## HISTORIC PRESERVATION ADVISORY COMMISSION STAFF REPORT

MEETING DATE: March 23, 2021

PROJECT: Application No. 2021-00000003 (Fraiman Office Exterior Modifications);  
Owner: Daniel Fraiman; Agent: Brendan Riley; 10270 Donner Pass Road  
(APN 019-080-028)

Agenda No.: **6.2**

Figure 3 – Historic vs. non-historic portions of building

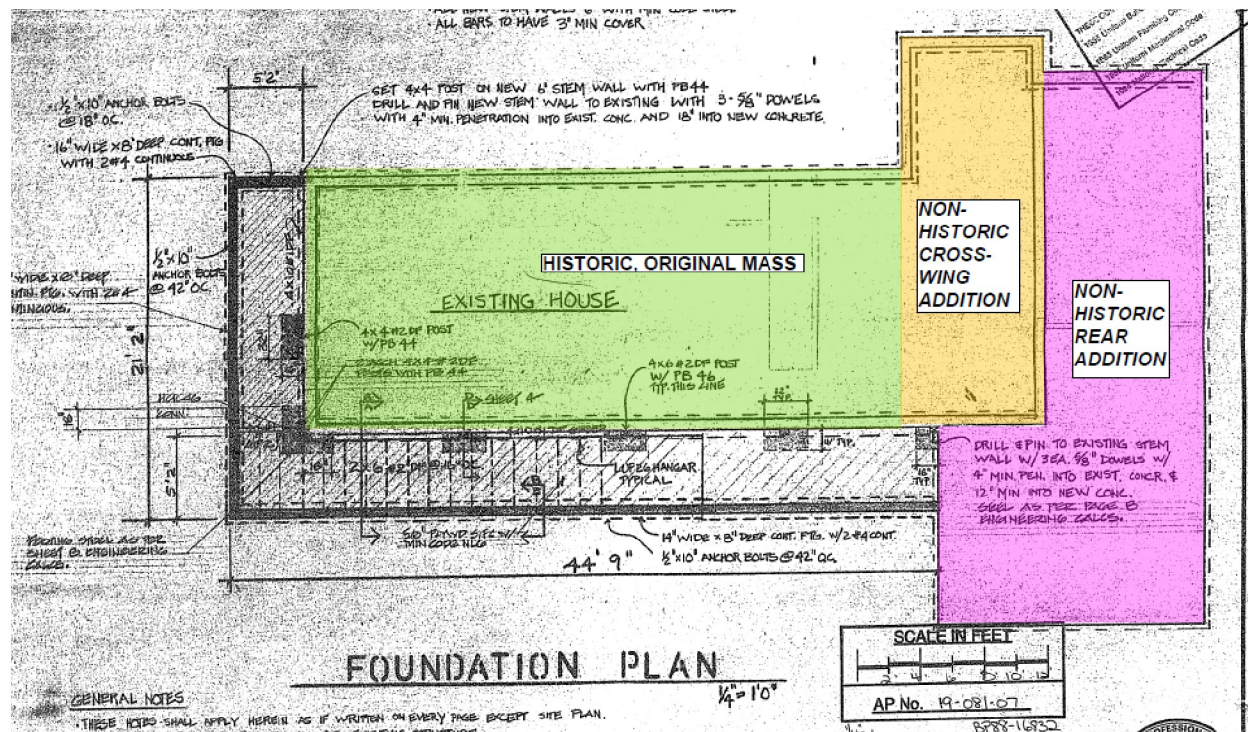
While the survey record does not describe nor provide a date of construction for the modern additions, the applicant’s structural evaluation of the building’s interior revealed modern framing and construction materials distinctively different from the framing and materials comprising the historic masses (Attachment #3). The modern additions show use of dimensional framing lumber (2x4 and 2x6 lumber), plywood sheathing, modern Simpson-style fasteners, and concrete masonry unit (CMU) foundation. In contrast, the original massing shows use of historic, non-dimensional lumber and no plywood or modern fasteners.

Figure 13 – Example of window proposed for replacement

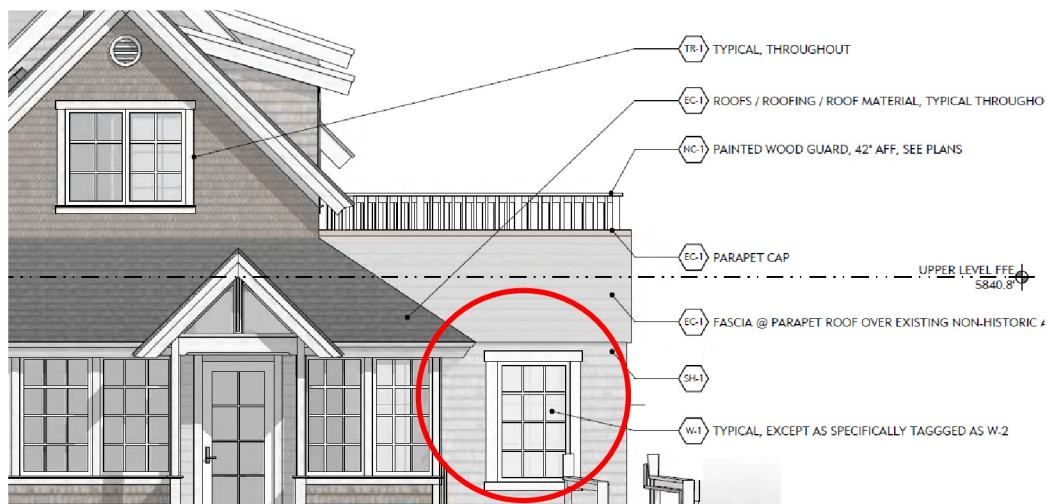
Staff supports the proposed replacement of the failing, existing vinyl windows. However, staff would like the HPAC to consider whether aluminum-clad wood windows are an appropriate window material for a Category “B” (Contributing) building.

Figure 15 – Location of window on second-story, western façade proposed for removal

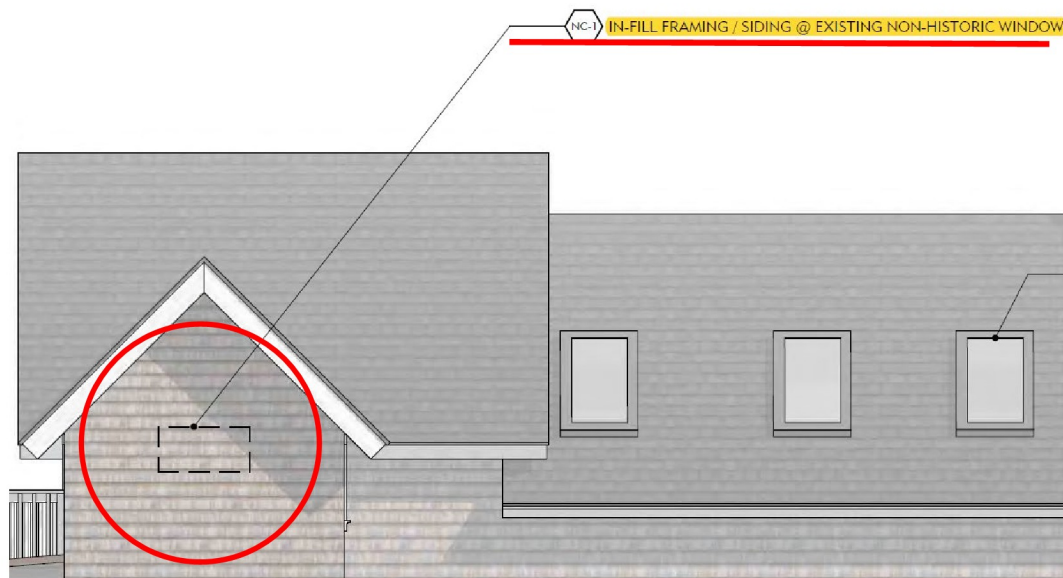
The applicant contends that the entire two-story, northern cross-wing addition within which this window occurs is non-historic, which would mean that the western “laundry room” window proposed for removal is also non-historic. Staff requests that the HPAC consider whether the Historic Design Guidelines which relate to restoration of historic openings truly apply to this specific proposal, and whether it is ultimately appropriate to remove the western window beneath the cross-wing gable to be replaced with sheathing and shingles to match existing. Staff supports removal of the non-historic pyramid skylights, as they are not of historic significance and detract from the historic character of the building.

Figure 17 – Non-historic pyramid skylights proposed for removal

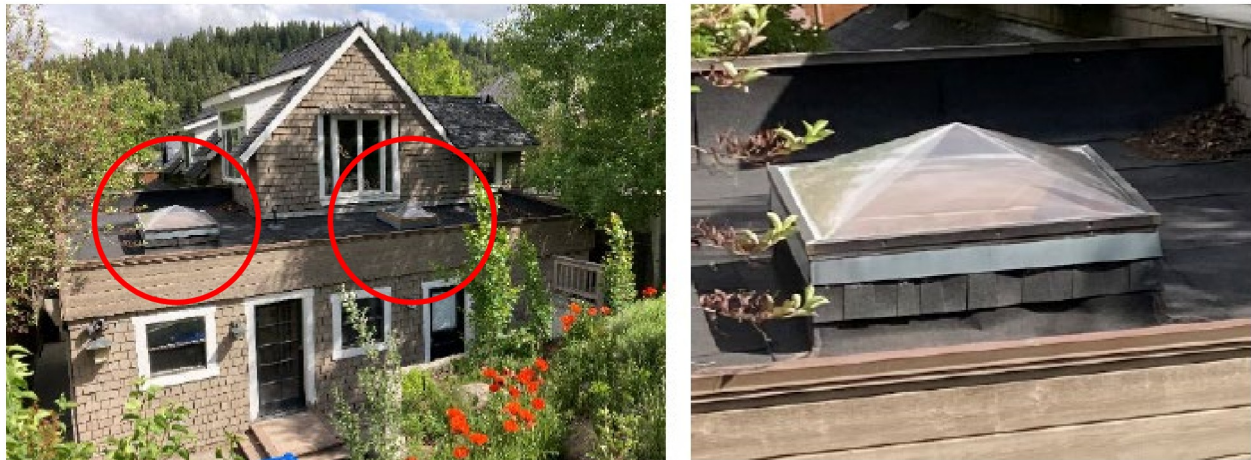
Two modern pyramid skylights within the non-historic rear addition to the north of the building are also proposed for removal. The removal of these skylights will accommodate construction of the sleeper-framed rear terrace addition which is proposed above the existing parapet roof.

Figure 18 – Rear exterior stairway proposed to be replaced

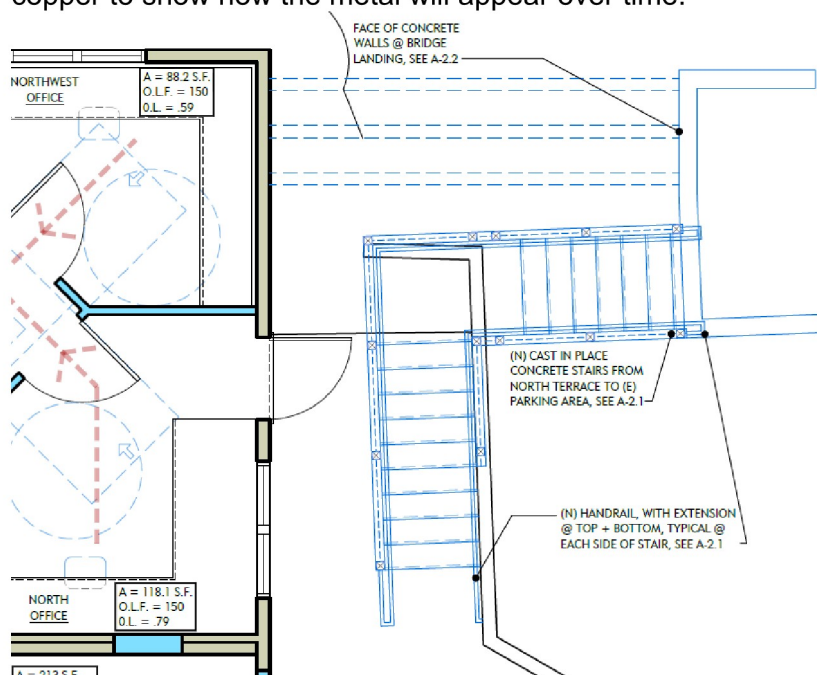
Staff has no concerns for the stair replacement, although it is apparent that the existing metal railing at the front access ramp (along the eastern side of the building) appears to be painted white.

- Rear stair replacement: Should the copper railing proposed to be installed in conjunction with the reconstruction of the rear concrete and wood-framed stairs be made to match the existing, painted metal railing along the eastern access ramp? Should the existing metal railing be restored to raw metal, or be replaced with copper railing?

Figure 20 – Existing monument sign with no tenant panel (L); 1997-approved monument sign (R)

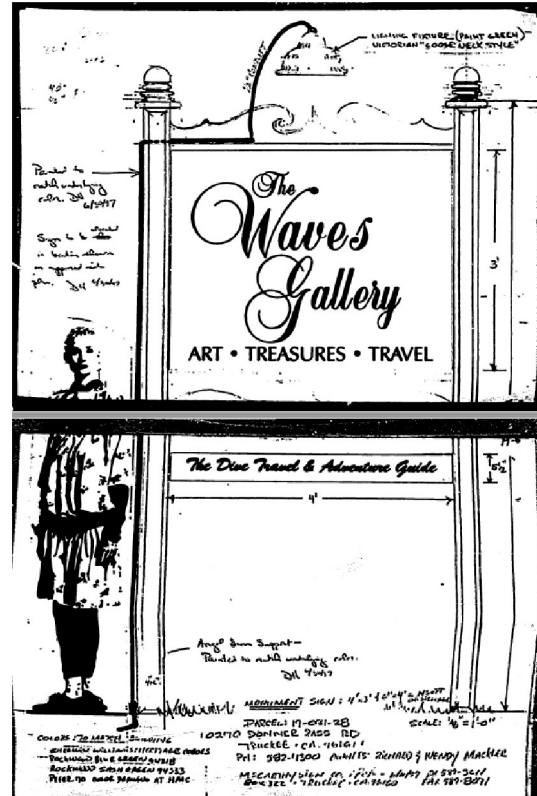
So long as the dimensions and material of the proposed signage are consistent with the previously-approved signage documented under Building Permit No. 97-4731 and current sign regulations, staff would be able to review the proposed signage under the Historic Design Review Streamlining Guidelines for signs. Staff recommends that the HPAC direct the applicant to work with staff in reviewing proposed signage prior to issuance of building permits for the proposed exterior modifications.
